## VENDOR SERVICE PUBLICATION

**SUBJECT:** CONTINENTAL AEROSPACE TECHNOLOGIES, SB20-01, 'FUEL SCREEN ASSEMBLY, SCHEDULED MAINTENANCE'

**SERVICE BULLETIN****SB20-01**

**SUBJECT:** Fuel Screen Assembly, Scheduled Maintenance**PURPOSE:** Augment current scheduled maintenance instructions**COMPLIANCE:** During the 100-Hour/Annual Inspection**MODELS****AFFECTED:** All Continental Aerospace Technologies new and rebuilt aviation gasoline (AvGas) engines equipped with throttle and control assemblies (reference Table 1).**I. GENERAL INFORMATION**

**Figure 1. Fuel Injection Control Assembly - Exploded View, typical**  
(Shroud, levers, and hoses removed for clarity)

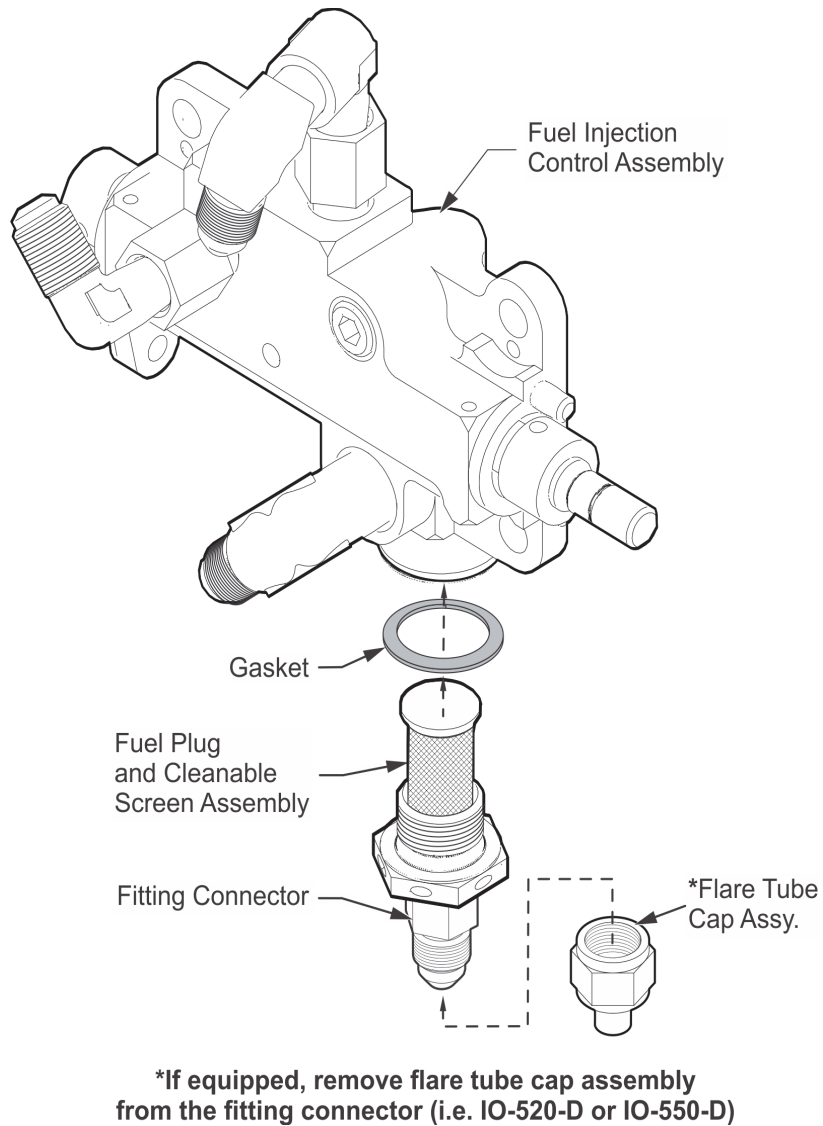
1. Cut, remove, and discard the safety wire from the fuel screen assembly.
2. Remove the fuel plug and screen assembly (with gasket) from the fuel injection control assembly housing; discard the gasket (see Figure 1). If equipped with a fitting connector and flare tube cap assembly, remove the flare tube cap assembly from the fuel plug and screen assembly (i.e. IO-520-D or IO-550-D). Inspect the fuel screen for damage.

- a. If the screen or plug threads exhibit damage, replace the fuel plug and screen assembly.
  - b. If the fuel plug and screen assembly appears to be serviceable, clean the fuel screen according to the instructions in M-0, Standard Practice Maintenance Manual, Table 12-1. Repeat the cleaning process until no debris remains in the screen.

- c. If the screen cannot be cleaned successfully, replace the fuel plug and screen assembly.
3. Apply anti-seize lubricant (P/N 646943) sparingly to the male threads of the fuel plug and screen assembly, ensuring the screen material does not become contaminated.

4. Install the fuel plug and screen assembly (with new gasket) into the fuel injection control assembly housing by hand. If a flare tube cap assembly was removed (reference step 2., above, (i.e. IO-520-D or IO-550-D)), install into the fuel plug and screen assembly according to the latest version of M-0, 3-3.1. General Sealant Application Instructions.

5. Torque the fuel plug and screen assembly (with new gasket and, if equipped with flare tube cap assembly) to 120 - 130 in-lbs according to the latest version of M-0, Appendix B.

6. Using new 0.032” safety wire; safety wire the fuel screen assembly to the anchor point on the fuel control assembly housing according to instructions in M-0, “Standard Practice Maintenance Manual, Table 3-8 (wire size), and Appendix C-3 (method).

**Figure 2. Affected Throttle and Control Assembly, typical**

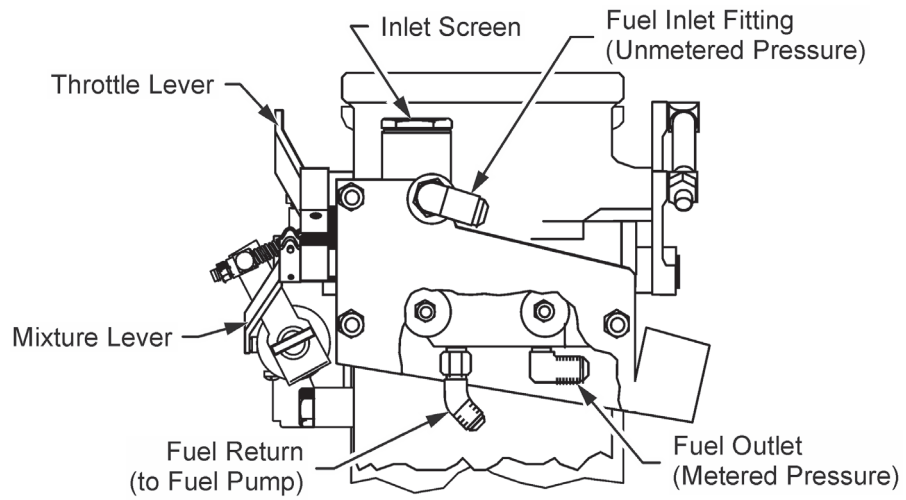
Continental engines equipped with a throttle and control assembly (see Figure 2 on page 4) use a fuel screen assembly and are affected by this service document. Continental engines equipped with a metering assembly that is integral to the air throttle body (see Figure 3 on page 4) **do not** use a fuel screen and are not affected by this service document. In addition, these assemblies may have multiple part numbers due to configuration, however they may be identified by the rectangular base body that is distinctly separate from the air throttle body.
